Reply to reviewer's comments

Reviewer#1, Graham Cogley

This paper presents a large-scale glacier inventory covering all of High Mountain Asia, dated to the period 1999–2003 and relying on Landsat imagery and the digital elevation model of the Shuttle Radar Topography Mission (among other data sources). A huge amount of work has been done and documented carefully. Quality control and accuracy tests (leading to an estimate of region-wide accuracy in glacierized area of about 15%) are presented, and the new inventory is compared to an inventory of Bhutanese glaciers relying on ALOS imagery and to the recently published Randolph Glacier Inventory (RGI). The RGI is a global inventory, and in much of the present study area it is in fact the Chinese Glacier Inventory, which is the result of a major effort some 30 years ago based on surveys 20 to 40 years before the date of the new inventory.

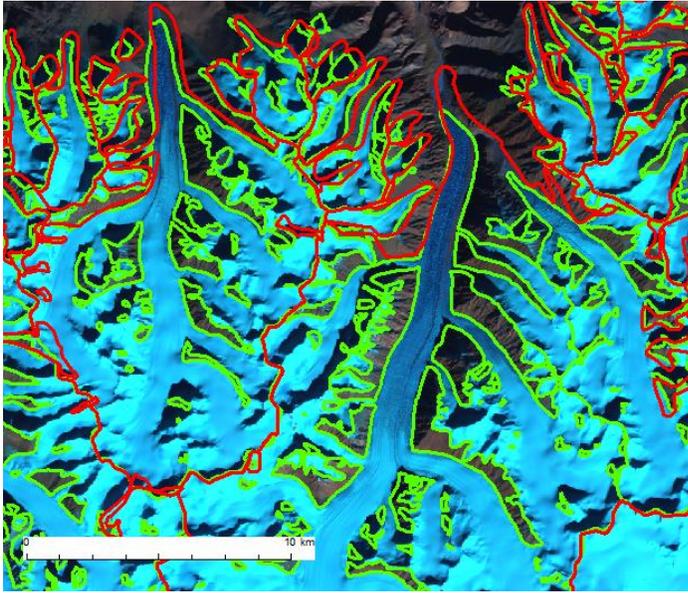
L28 “high-relief headwalls”: an important reason for the greater glacierized area in the RGI than in the GGI must be the ~30-year difference in their dates (P2810 L3-5), but the assumption in this sentence that high-relief headwalls ought not to be included raises a complex and open question which needs further discussion in the paper.

One has to decide, usually on the basis of a single satellite image, whether the steep slope is ice-covered; commonly this decision is unreachable because the slope is snow-covered, and a further decision is required about whether the slope is so steep that all the snow will fall off between the image date and the end of the mass-balance year. If it were to do so, and whatever was beneath the snow were thus exposed (and observed, which is unlikely), the question would have an answer. Short of this ideal, I think there is genuine ambiguity given the present state of observational knowledge. Perhaps there is a role for time-lapse photography of steep valley walls in resolving the problem.

A further difficulty is that it is not clear how those who worked on the Chinese Glacier Inventory approached the problem, or even whether the problem was recognized at the time.

As your comment, it is difficult to judge ice or snow covered area by several instantaneous images. We excluded steep walls, where snow can not accumulate, even we found those walls are covered with snow in the images. Because those walls contribute as source of avalanche nourishment, but elevation change due to glacier mass fluctuation are not expected (below figure).

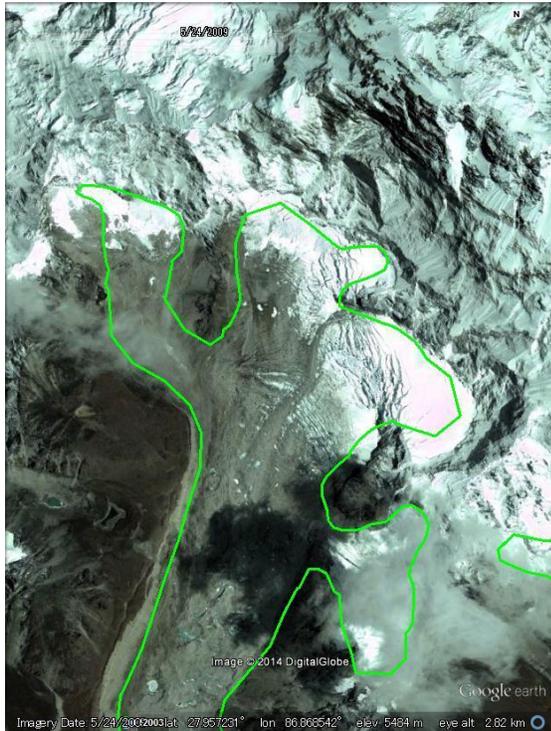
Figure S1 This is potentially quite valuable, but needs further documentation.

a: Add an outline of the steep headwall, which I cannot find. If it is the bright white patch at right centre, I need more information before accepting its exclusion from the glacier; it looks like an ordinary accumulation zone to me.

We added outline of glacier in GGI (see below figure). The bright white patch at right centre is not steep headwall which we specified. The steep headwall is located upper of the green coloured outline. And we will move this figure to the main text as reviewer#4 (Frank Paul)'s comment.

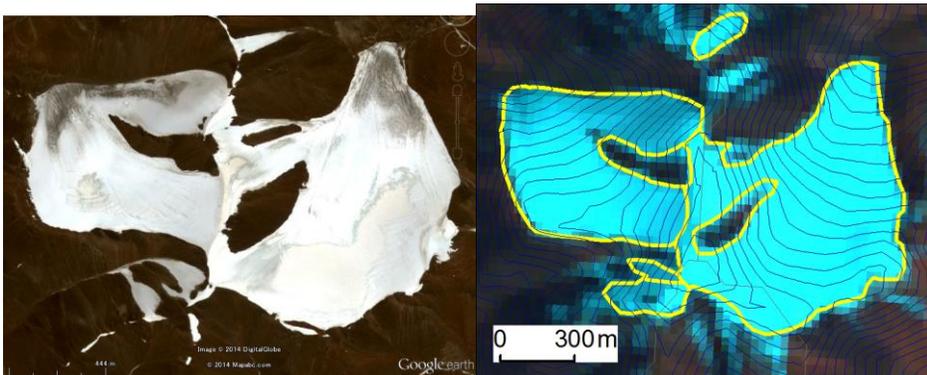
f: *The scales appear to differ between the two panels. I can only guess that the orange rectangle in the left panel represents the extent of the right panel, and I do not know what conclusion I am being invited to draw – that the blue patch on the left is or is not a glacier.*

We will replace images. Both images (LANDSAT and Google Earth image) will be extracted in same scale. The Google Earth image (right) shows the snow surface is undulate and looks like covered with thin snow (not smooth glacier ice). Therefore, we can judge there is no ice under the snow cover.

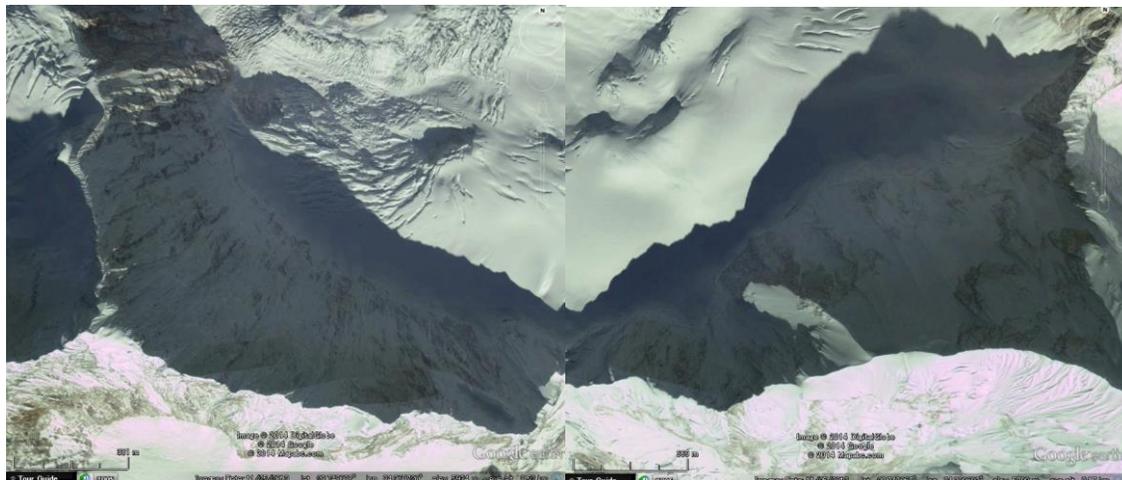
Figure S2 Again potentially valuable, but I do not know which colours represent right and which represent wrong decisions about delineation.

a: In the deep shadow on the south side, I would accept the orange outline (following the topographic divide) as correct, and I can see no basis for the decisions marked in red, green and blue.

From above Google Earth image, rock wall exposed at the southern steep walls. We, therefore, judged that the orange line is not correct.

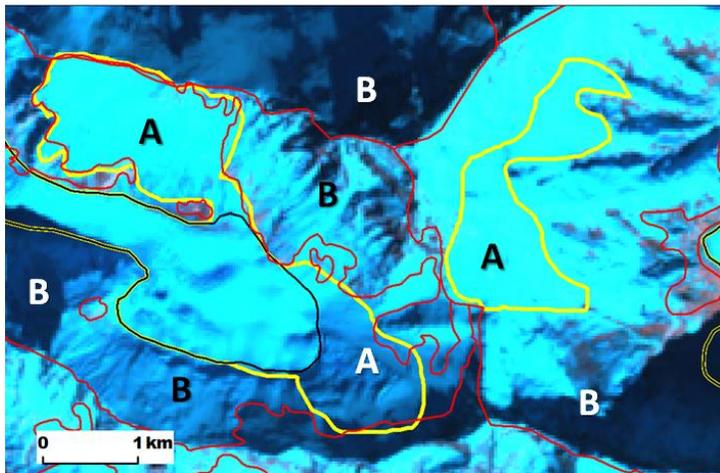
(1) *general comment, this (exclusion of steep rock walls) makes the new outlines incomparable to other existing datasets and is strongly limiting their usability for other applications when made available.*

Below three figures show glacier outlines from the RGI (Red), before revision (under-estimated at steep slope) of GGI and after revision (include snow accumulate able area) of GGI.

Landsat image taken in 20 Oct. 2001

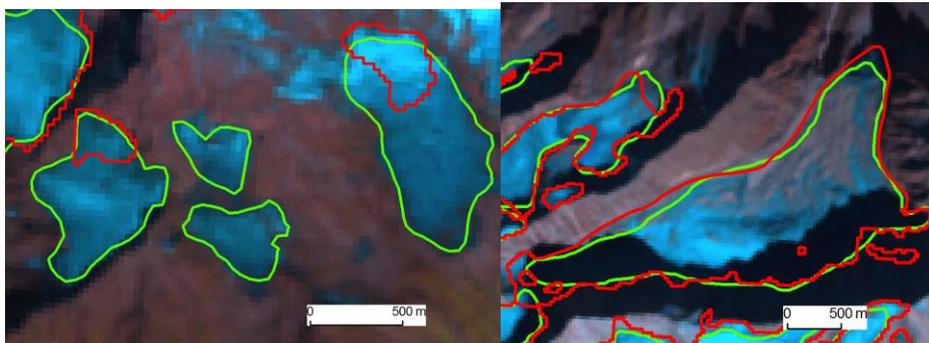
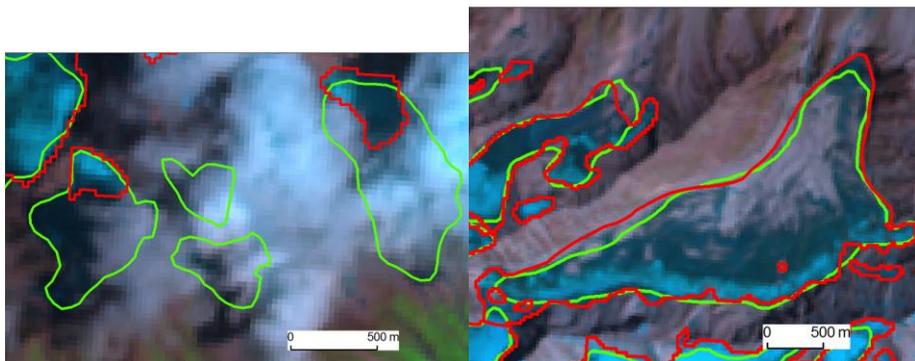
2) The Asian region tend to covered with seasonal snow or partly cloud cover during the high solar angle season (summer) because of the monsoon. So, it is difficult to get clear seasonal snow-free, cloud-free and shadow-less images. Eventually, a lot of manual corrections for clouds, shadow, debris cover and seasonal snow are required after automated processing. (Rastner et al., 2012)

For example, a Landsat image at path 145 row 039. Image taken in 1 Aug. 2001 has a lot of cloud cover so, automated mapping needs more corrections. On the other hand, an image taken in 20 Oct. 2001 has no cloud, but solar angle is low (a lot of shadow area).

The image has no cloud (left), but has a lot of shadow part (right). RGI (Red), GGI (Green).

Landsat image taken in 1 Aug. 2001

Part of the image are covered with cloud, so automated method needs more correction.

Figure Schematic glacier outline at glacier with head steep wall. GLIMS inventory (Red), GGI (Blue), required polygon for calculation of accumulation (Purple).

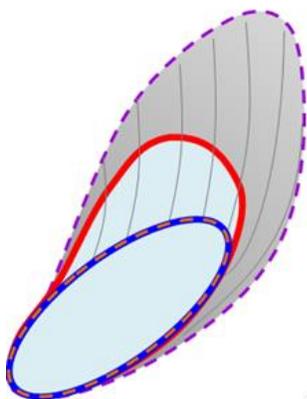
2) Elevation change of glacier surface (volume change)

Our direct purpose of making our inventory is second one, to estimate elevation change of glaciers. Therefore, we excluded steep slopes, where snow can not accumulate. Actually, estimating elevation change is not equal to our final purpose (estimating discharge from glacier). But, measuring elevation change of glaciers is equivalent to estimate imbalance of glaciers (only multiplying density of snow or ice or not), which represents the effect of glacier volume change on river runoff as Kääb et al. (2012) reported. We did not wrote the detail of our purpose in the manuscript, we will add in the revised version.

In order to calculate glacier mass, accumulation and ablation cannot calculate by one glacier polygon for a certain glacier with steep headwalls. Because the area receiving precipitation (snow) is different from the glacier area settling snow or ice. If we calculate accumulation excluding ice-free head wall, the accumulation will be underestimated. Eventually, both GLIMS and GAMDAM inventory needs another inventory for glacier accumulation area, like PDS (potential debris-supply, potential material supply) proposed by Nagai et al. (2013). The ideal polygon for calculation of accumulation is depicted in the below figure (Purple dotted line).

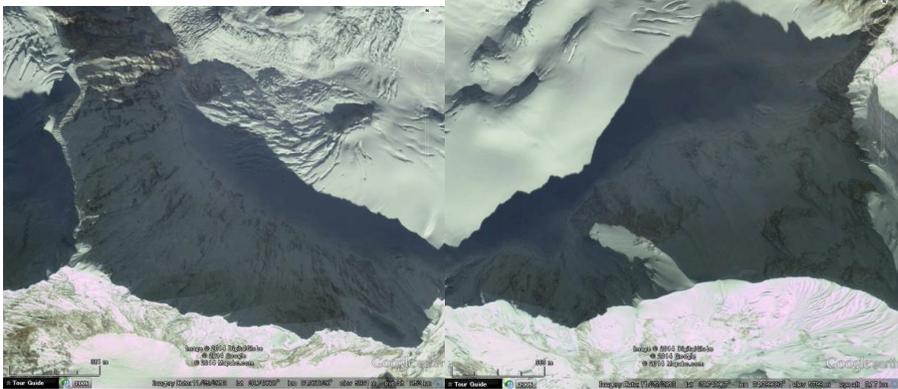
L19/20: When specific surface features are obscured by shading, there is no need to assume that there is no ice underneath and exclude these regions. Very likely (as I can judge from Fig. S2a) the orange line is much closer to the correct outline than all others, i.e. that was not a misidentification of the glacier but the correct one.

Above figure shows the Google Earth image of southern walls (dotted circle) of the glacier in Fig S2a. Rock surfaces are exposed at those walls. Therefore, Orange line is not correct.

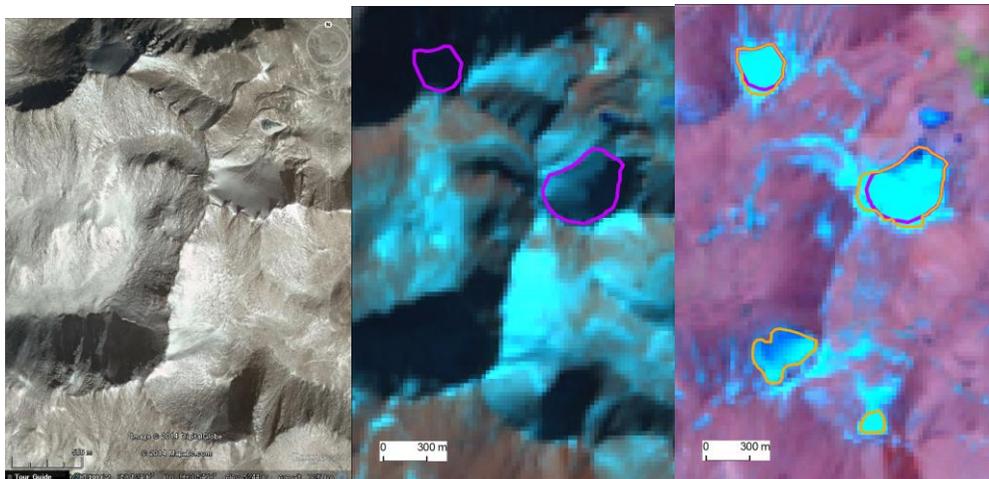
L1: This reads like the second operator has special knowledge that cannot be shared beforehand with those doing the work and that this expertise is always the correct one. Please show examples of what this second operator is correcting to learn from it (or even better: use the same rules for all operators).

As we wrote above, delineation works were carried out by field work experienced operators and non-experienced operators. If the glacier polygon was made by non-experienced workers as first operator, field work experienced workers reviewed as second operator. Even if the glacier polygon was made by experienced workers, other field work experienced workers reviewed as much as possible.

Below example shows that first operator used Landsat image taken in the winter season (7 Jan. 2003) (Purple), but second operator changed source images in the summer season (12 Jul. 2001), then second operator could add shaded glaciers (Orange).

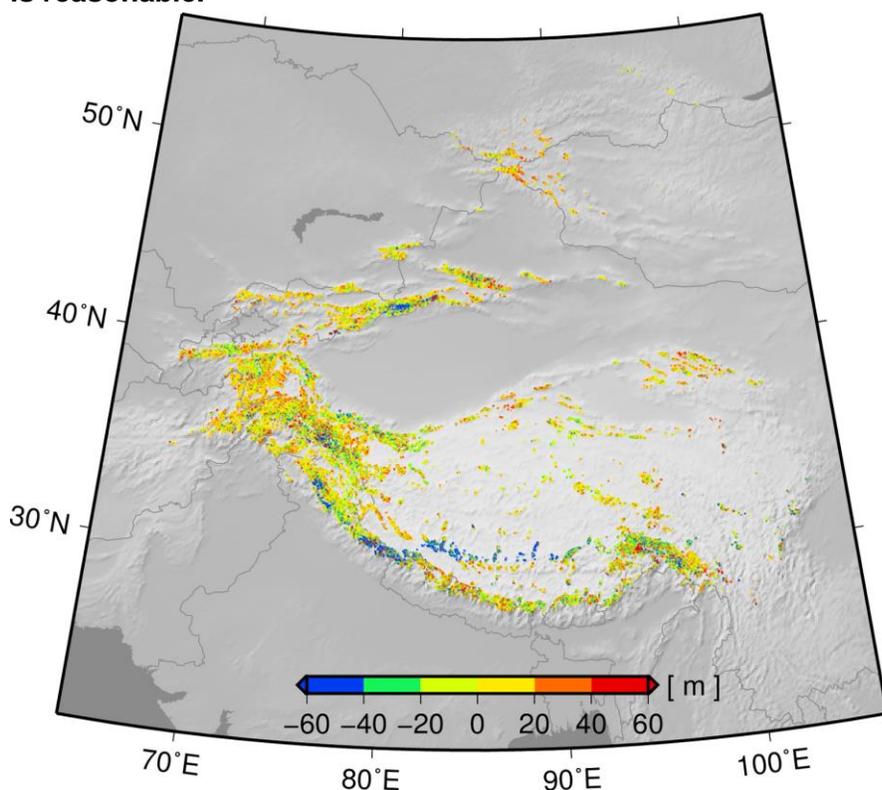
Fig. 2: As a justification for selecting a specific DEM, I suggest to simply subtract the GDEM from the SRTM DEM, add a colour coding in classes of standard deviation, and a layover of glacier outlines (of course, this could only be shown for a subregion). The comparison with ICESat is interesting in general, but in the framework of this study I would suggest showing something more relevant (glacier specific).

Below figure shows difference of median elevation calculated using SRTM DEM and GDEM (SRTM - GDEM) in each glacier. It shows large difference around western Himalaya, Karakoram and Hengduan Shan. However it can not show which DEM caused the large differences. Both SRTM DEM and GDEM have their characteristic superiority and deficiency. Therefore, we consider DEM evaluation against same reference data (ICESat) is reasonable.

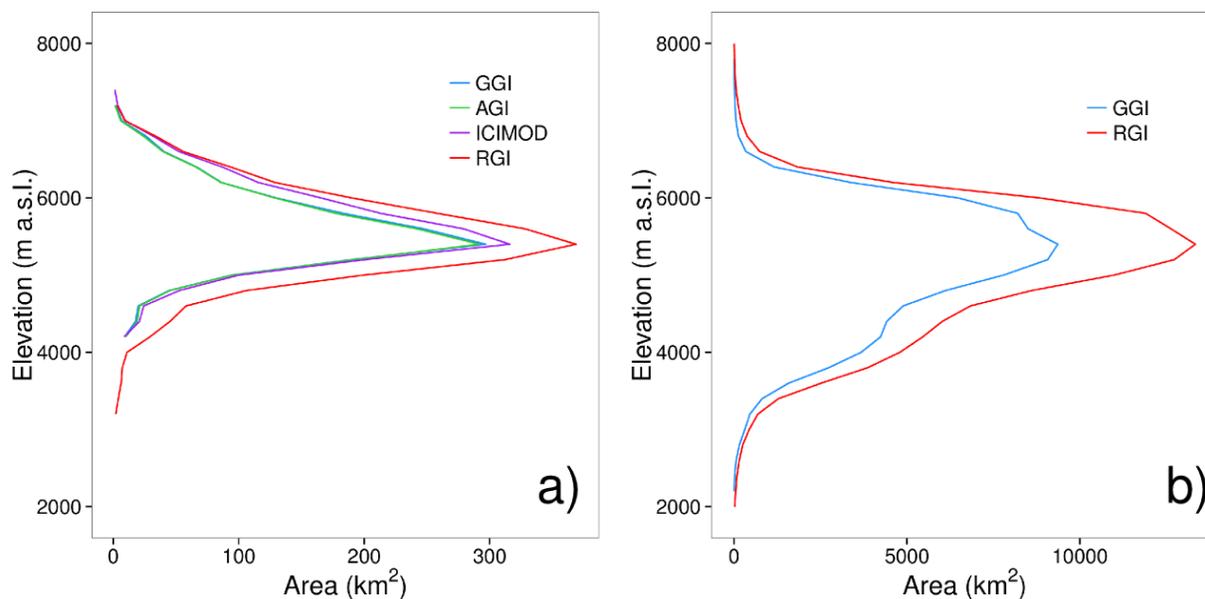
Fig. 6: When retaining this figure, I suggest removing the comparison with the entire RGI and focus on more regional comparisons with other high-quality datasets. When hypsometry is shown, it would be nice to indicate how the sampling is done (e.g. in 100 m bins?).

We will add sampling interval (200 m bins) in the figure caption. And we will add hypsometry comparison with ICIMOD's data as below figure.

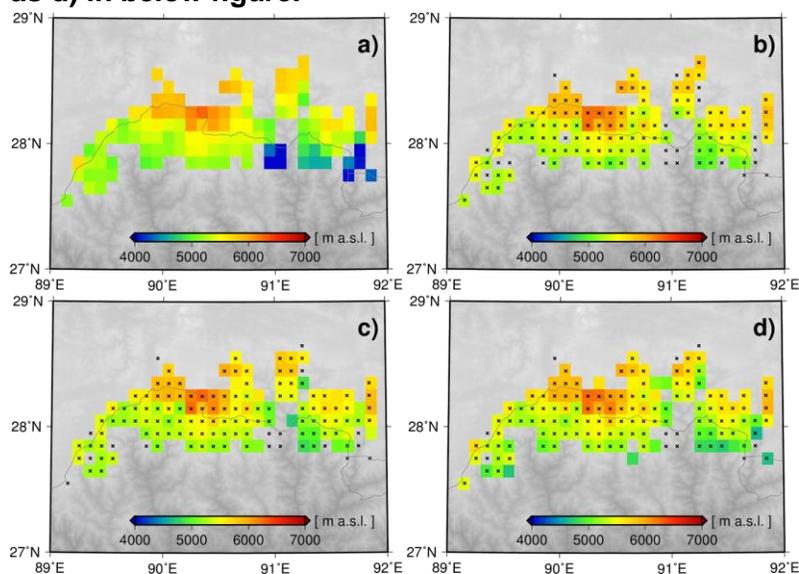
Fig. 7: I suggest removing the comparison with the RGI dataset and instead of c) showing the difference between b) and c)

We will add distribution of median elevation of glaciers derived from ICIMOD inventory as d) in below figure.

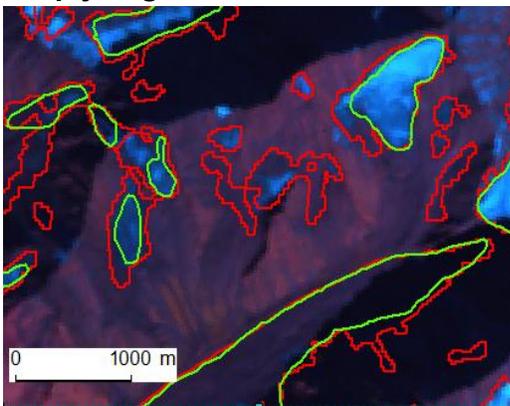
Fig. 10: The comparison with high-quality outlines as shown in a) worries me. I have compiled comparisons with high-resolution screen shots from Google Maps on page 7, showing that the GGI quality is partly rather poor compared to the RGI. It seems that GGI is highly generalized (like the DCW) and that the second operator has also problems in interpreting glaciers correctly. The poor-quality regions shown in b) and c) have already been documented by Pfeffer et al. (2014) and have been revised in the mean time (for RGI 4.0). There is no need to show them here. The red line on d) is certainly not correct, but why has the glacier in the upper centre and at the Lhotse westface been removed? Please also check the Mt. Everest map from swisstopo or the National Geographic Society for a correct interpretation of glacier extents in this region and see comparison on page 8. Caption: I think the normal way of providing geographic coordinates is latitude, longitude.

We revised the delineation in Fig. 10 a) as follows. Detail of our replies are written at the “Reply to general comments”.

We will delete Fig. 10 b) and c). As for Fig. 10 d), accumulation area at Khumbu Glacier. Detail of our replies are written at the “Reply to general comments”.

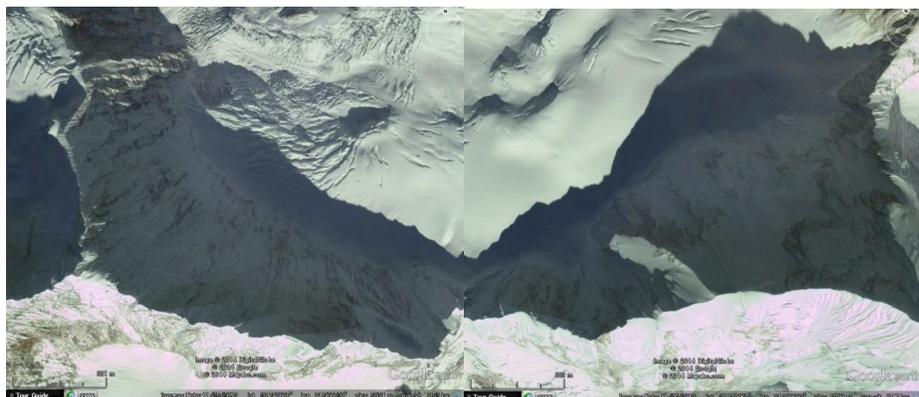
Fig. S2: The orange line might be more correct than all others (see example on page 8). Is there an image available showing that there is bare rock under the snow?

Below figure shows the closeup image of the southern walls. We can find bare rock surface.
